SERVICE RECEIVED LETTER

No. 564

Subject: Revised Hartzell Propellers

Service Letter No. 62

Instructions for Installation:

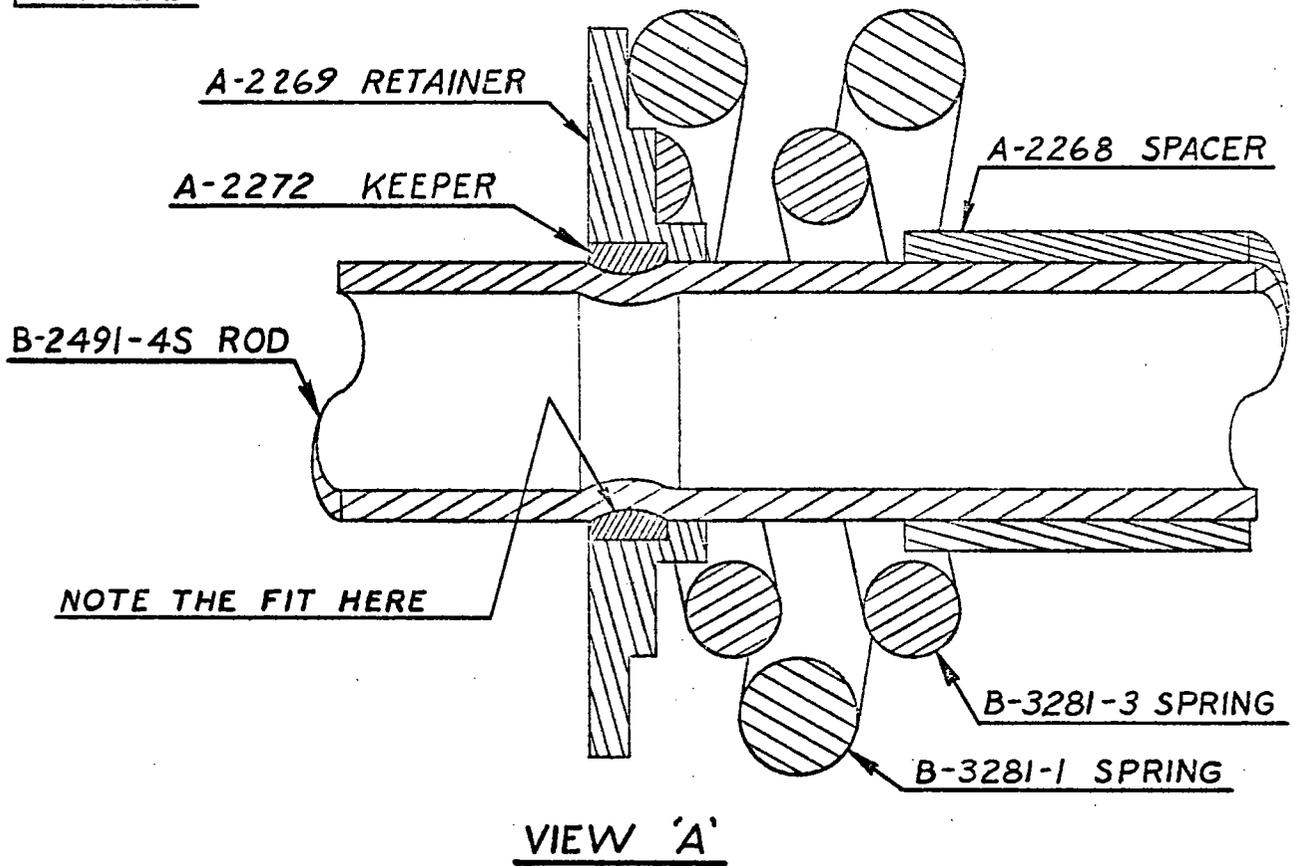
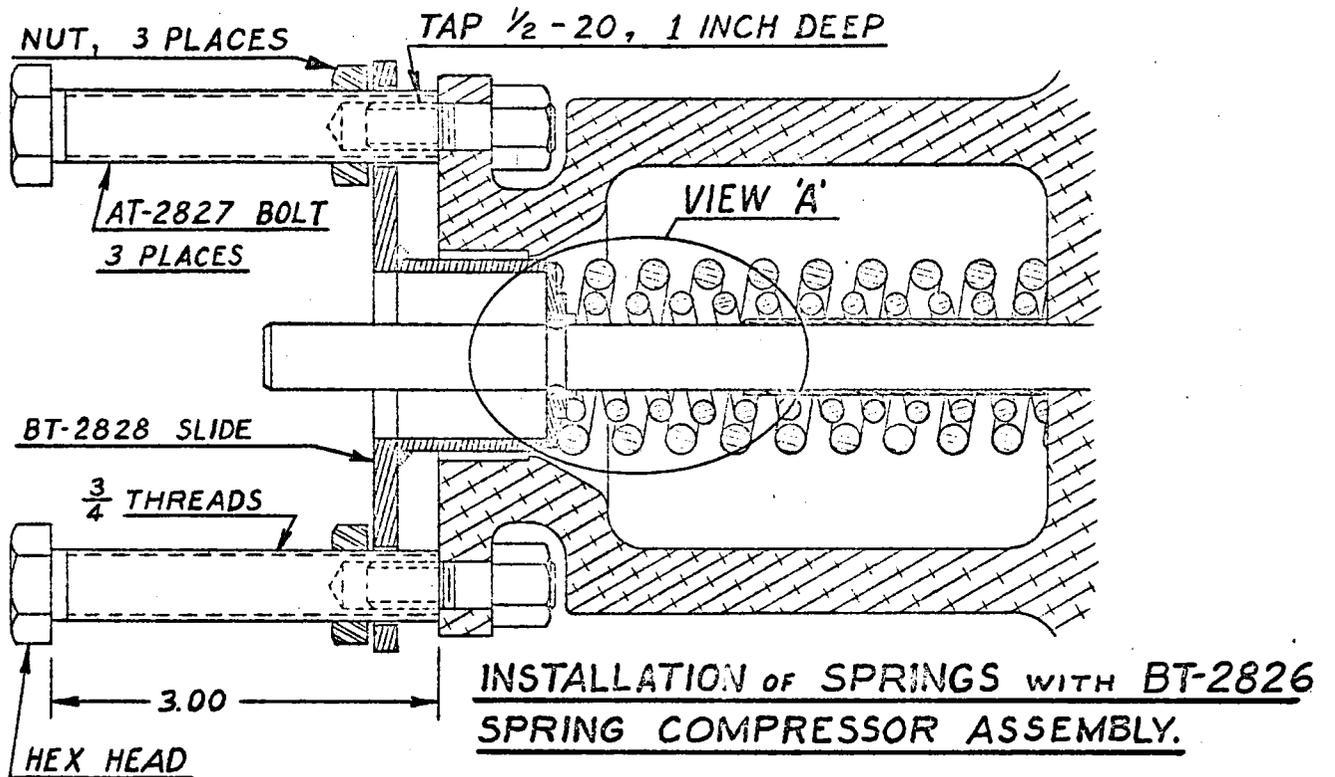
- 4) Install the spring kit in the extension shaft cavity, as shown in the following sketch, as follows:
 - (a) install A-2268 spacer on the B-2491-4S rod
 - (b) install the B-3281-1 and -3 springs over the spacer
 - (c) install the A-2269 retainer as shown
 - (d) compress the springs with special spring compressor, P/N BT-2826
 - (e) install A-2272 keeper in the groove formed in the B-2491-4S rod, as shown in the enlarged sketch
 - (f) remove spring compressor, allowing the springs to bear against the A-2269 retainer
- 5) Unfeather the blades with pressure applied through B-2491-4S rod, or by means of blade arms applied to both blades.
- 6) Recharge the cylinder with dry air or nitrogen to:

70 PSI @ 70° F. for the HC-E2YK-2RB	}	PA-23-250
70 PSI @ 70° F. for the HC-E2YR-2RB	}	PA-E23-250
50 PSI @ 70° F. for the HC-E2YL-2B	-	PA-30 and PA-39
- 7) Install new table of pressures inside the spinner cap in place of the old decal, and also on propeller cylinder. Decals are included in the A-2273 kit. Also install CA-003 decal on spinner near air valve.
- 8) Add the letter "S" after the hub dash number, which is located on the side of the hub, as: HC-E2Y()-2()BS. Use a steel stamp.
- 9) For the PA-30 and PA-39 aircraft, remove the spring assembly which is located inside of the engine crankshaft. The parts consist of: A-2488 sleeve, 9-2410-3l spring, A-2487 thimble, and A-2496 shim. These parts are not required after the A-2273() spring kit is installed.
- 10) Install the propeller onto the engine crankshaft in accordance with appropriate installation instructions.
